From: William Fleming
Sent: 21/11/2024 4:59:59 PM
To: Council Northernbeaches Mailbox
Subject: TRIMMED: Submission re: 7 Coolenna Road, Elanora - DA2024/1376
Attachments: 5 Cooleena Road, ELANORA HEIGHTS (v2).pdf;

**DEVELOPMENT APPLICATION REFERENCE DA2024/1376
SUBDIVISION OF ONE LOT INTO TWO INCLUDING DEMOLITION WORKS, NEW DRIVEWAY
7 COOLEENA ROAD, ELANORA HEIGHTS**

Image 2: Lot 2 area map showing the POS

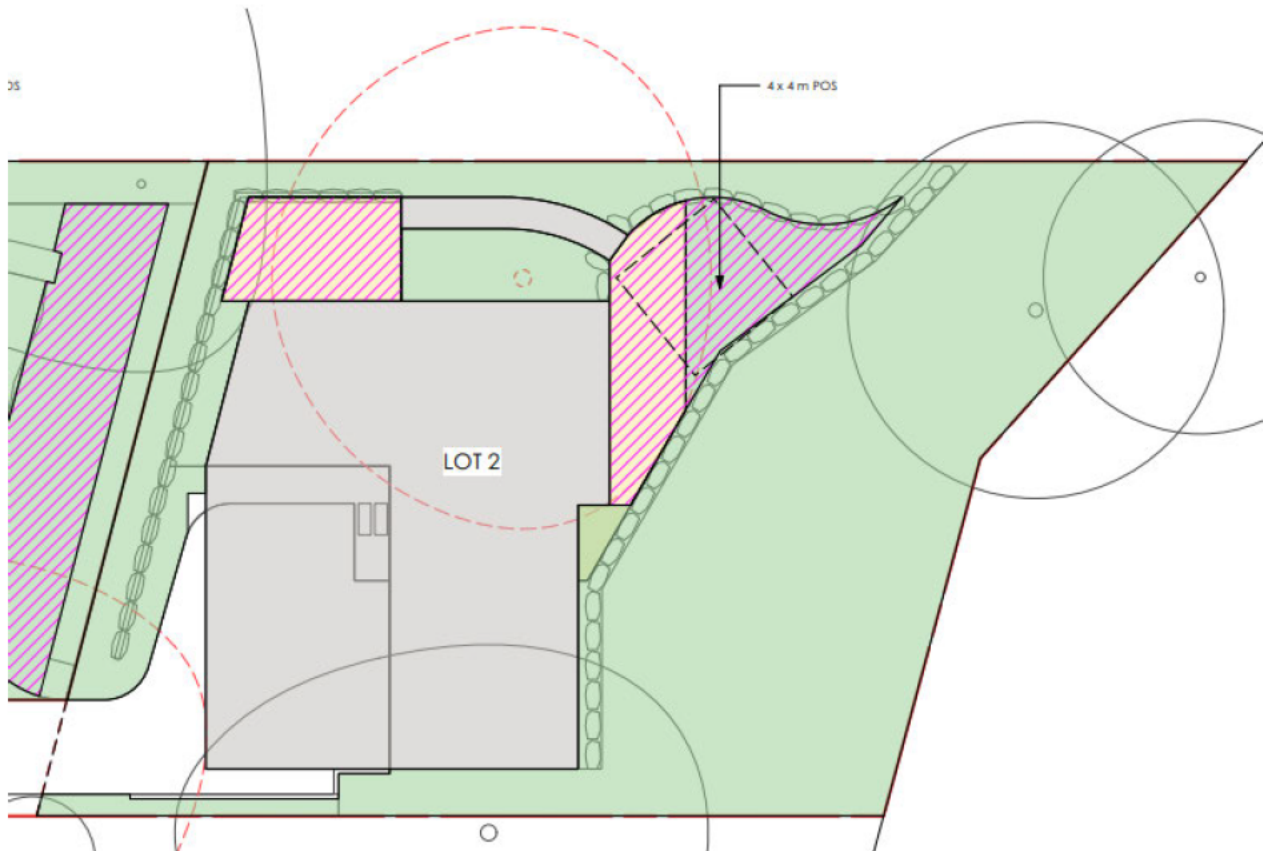
The application purports to claim that lot 2 can comply with the 60% control for soft landscaping and does not comply with the private open space requirements. The proposal identifies the area shown below as private open space for lot 2:

The POS area is located at RL40.50. The garage level is proposed at RL43.50 which will be the ground floor level of the new dwelling. The dwelling will have no direct access to the only nominated compliant POS area of the site. This is clearly demonstrated in the 3D drawings and shown below:

Image 2: 3D images show the private open space area and retaining walls not directly accessible from the dwelling

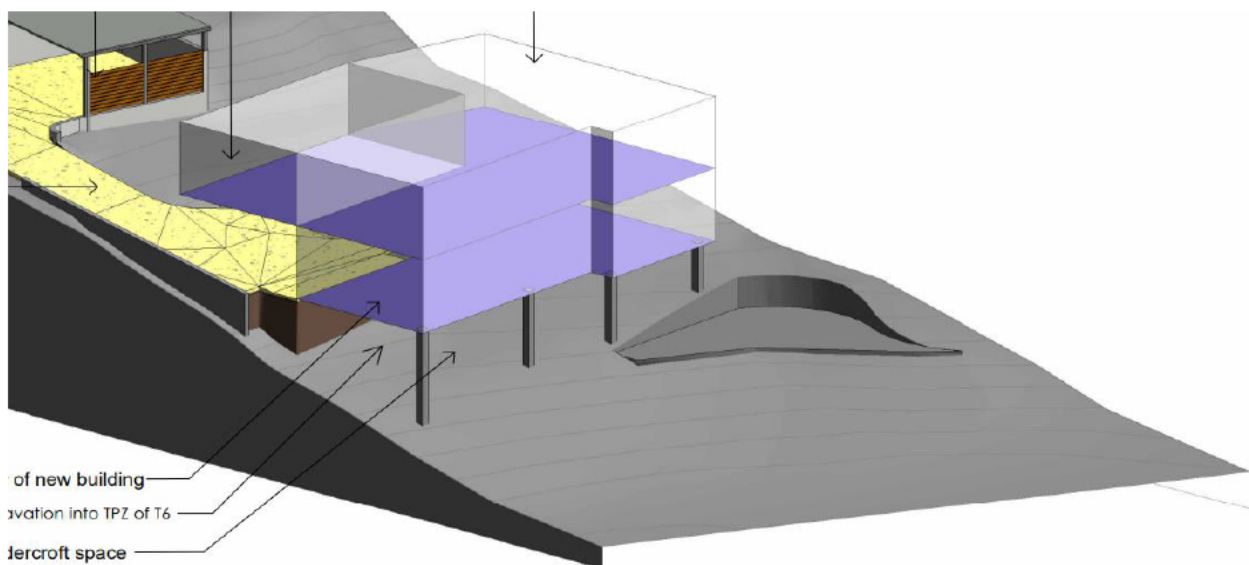
The SEE states that in relation to POS there is *“In reality a greater area is capable of being utilised for private open space functions.”*. If that is the case then please provide documentation to confirm that claim is true while complying the DCP control.

In reality this is a misleading claim. The only viable POS would be via balconies and it is unclear which level would include the main living areas of the home. No floor plans are provided. The balconies would need to be provided within the indicative building footprint also. The dwelling is proposed to be elevated above ground level which will raise increased privacy impacts, especially if the main living area and balcony is provided at the first floor level. To have balconies included as POS they need to have a minimum width of 2.4m.

It is considered that insufficient detail has been provided with regard to the dwelling. Floor plans should be provided with locations of any balconies to demonstrate compliance with the POS provisions.
